**ALERT SERVICE BULLETIN**

NO. 210-09-05

**MODEL AFFECTED:** 210

**SUBJECT:** 205-030-856-157/-159 ELEVATORS, ONE TIME INSPECTION OF.

**Figure 1**  
Angle Measurements

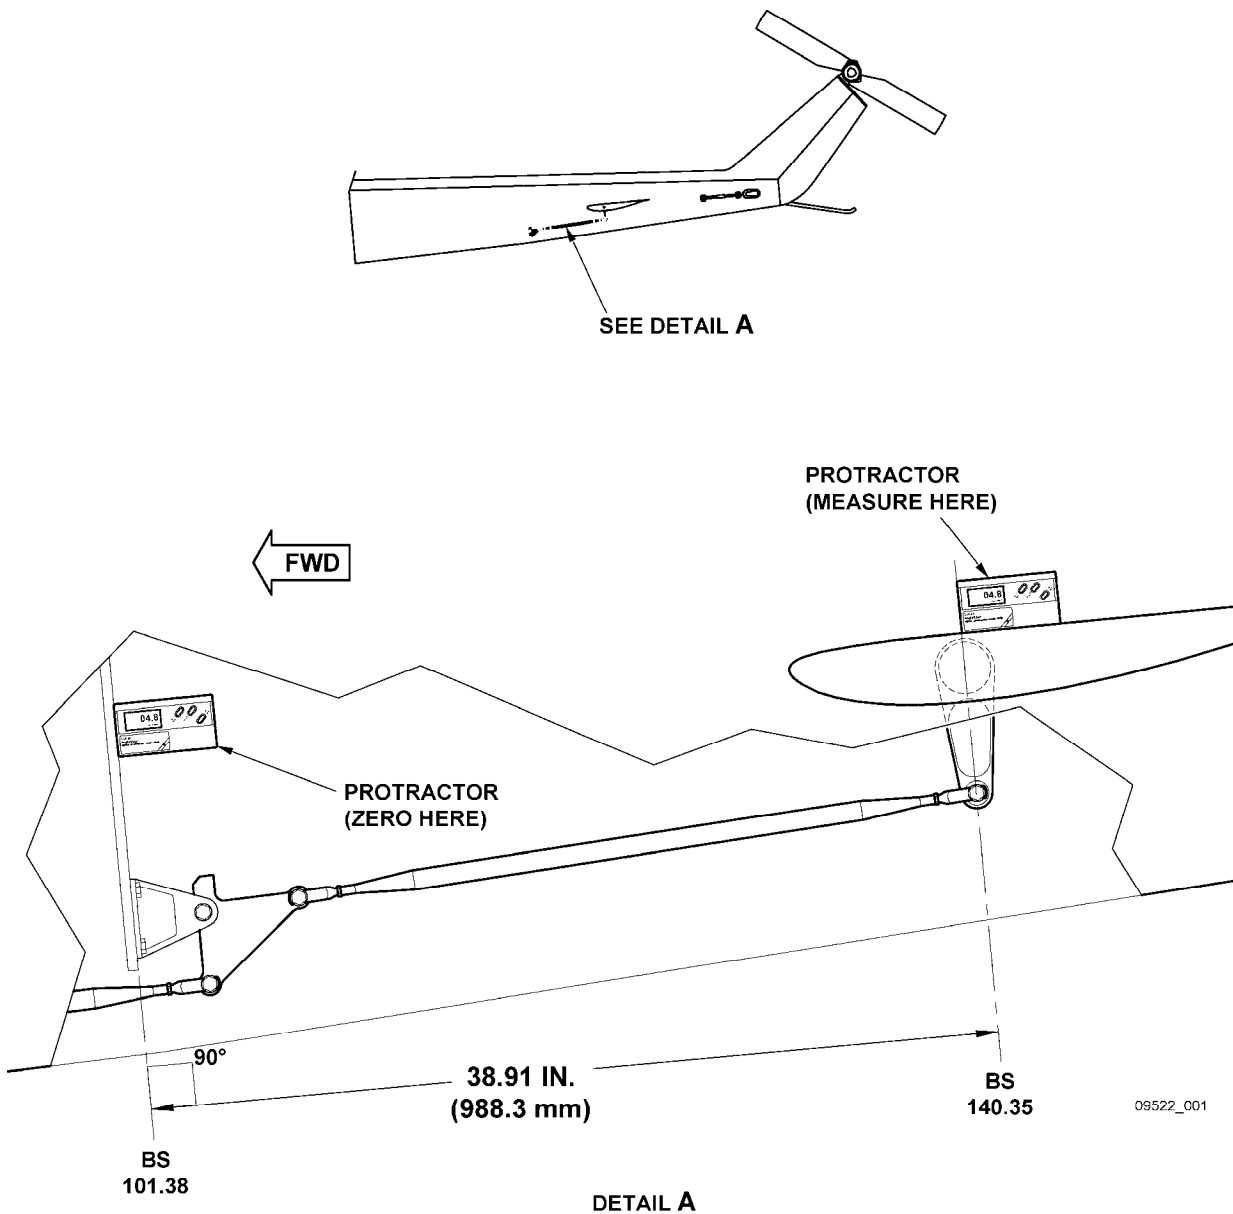
1. Prepare helicopter for maintenance.
2. Confirm elevator is within serial number range by referring to its bonded and riveted dataplate near the trailing edge.
3. Remove tailboom belly access panel just aft of Boom Station (BS) 101.38.
4. Using a measuring tape, position center of elevator horn control bolt at 38.91 +/- 0.03 inches (989.8 +/- 0.8 mm) from (and perpendicular to) the aft face of bulkhead at BS 101.38. Refer to Figure 1. Move cyclic controls as required and apply cyclic control friction when done.
5. Place digital protractor on aft face of bulkhead at BS 101.38. Zero protractor.
6. Move protractor to top skin of RH elevator second rib, edge of protractor should be aligned with the 8<sup>th</sup> rivet from the leading edge of the elevator. Record relative angle as Angle "A". Zero protractor.

Digital Protractor must be located and installed on the L/H elevator exactly in the same direction and location as positioned on the R/H elevator.

7. Move protractor to top skin of L/H Elevator and record the angle as Angle "B".

8. The correct value for Angle A is 0.00 +/- 0.50 degree. The correct value for Angle B is 3.00 +/- 0.75 degree.
  - a. If Angle "A" and Angle "B" are not within their applicable tolerance, replace the RH elevator as per Maintenance Manual within the next 100 flight-hours and proceed to Part II thereafter.

- b. If Angle "A" is not within its applicable tolerance but Angle "B" is within its applicable tolerance, replace the RH elevator as per Maintenance Manual within the next 600 flight-hours and proceed to Part II thereafter.

- c. If Angle "A" is within its applicable tolerance but Angle "B" is not within its applicable tolerance, replace LH elevator as per Maintenance Manual within the next 100 flight-hours. No further action is required. Go to Part II, step 6.

- d. If Angle "A" and Angle "B" are both within their applicable tolerance, both elevators are compliant and no further action is required. Go to Part II, step 6.
